REVIEW COMMENTS Project Name: Former Uniroyal-Facemate Property Filling Project Date: 1 July 2021 Location: Chicopee, MA Reviewers: Kevin DiRocco/ Patrick Blumeris USACE ICW Project: Chicopee Riv LB - Chicopee Falls, MA Reviewers: Kevin DiRocco/ Patrick Blumeris Documents Reviewed: (1) Letter prepared by BETA Group, titled Former Uniroyal-Facement Property Filling Project, Response to USACE Comments, dated May 20 (2) Letter prepared by O'Reilly, Talbot & Okun Associates for BETA Group, titled Chicopee Levee Slope Stability – Response to USACE Comments, dated May 12, 2021. Submitted By: BETA Group Submittal Dated: May 20, 2021

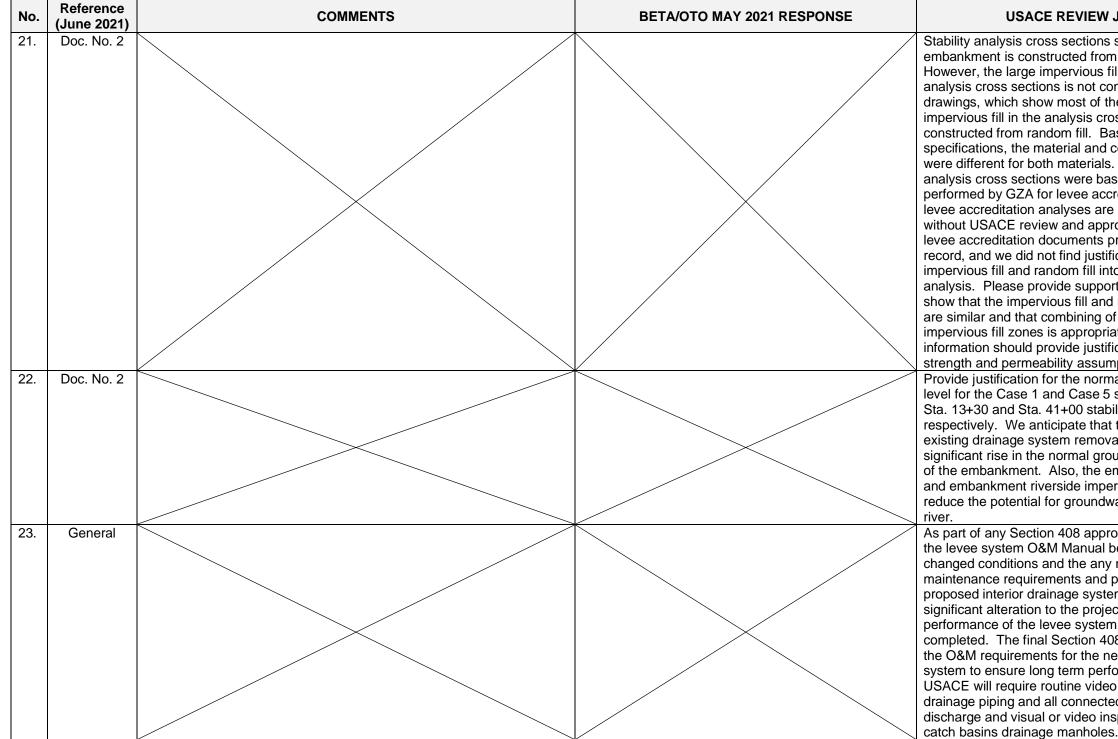
No.	Reference (June 2021)	COMMENTS	BETA/OTO MAY 2021 RESPONSE	USA
17.	Doc. No. 2	The stability report indicates that the rapid drawdown analyses were performed using the USACE 3-Stage Method. However, only drained strengths are provided in the report, which only applies to the first stage of the analysis. Provide the undrained strengths and final strength envelope used for the second and third stages of the analysis.	Refer to OTA letter dated May 12, 2021	The parameters us envelopes for the s drawdown analyses Appendix G of EM1 with the conclusion decrease the safety will raise the elevat landward of the lev could be a concern saturated under pro saturated under pro saturated under exi the likelihood of the saturated during a review of the as-bu zone on the riversio Uniroyal fill area is saturation of the im the embankment. N perforated HDPE p drain, lowering the Provide filter calcu geotextile to be us surrounding the p specifications for geotextile to ensu

used for developing the strength second and third stages of the rapid ses were not provided. Refer to M1110-2-1902. However, we concur on that the landward filling is not likely to ety factor for rapid drawdown. The filling ation of the normal groundwater level evee, and the elevated groundwater rn if impervious fill materials were proposed conditions that were not existing conditions. This would increase he impervious materials becoming a flood event. However, based on a built levee embankment, the gravel fill side toe of the embankment within the is expected to act as a drain, preventing impervious fill near the riverside face of Within the Facemate fill area, the pipe can be expected to act as a toe e landside groundwater level.

Iculations for the selected non-woven used around the crushed stone perforated HDPE pipes and provide or the envelope of material around the sure that the geotextile will not clog.
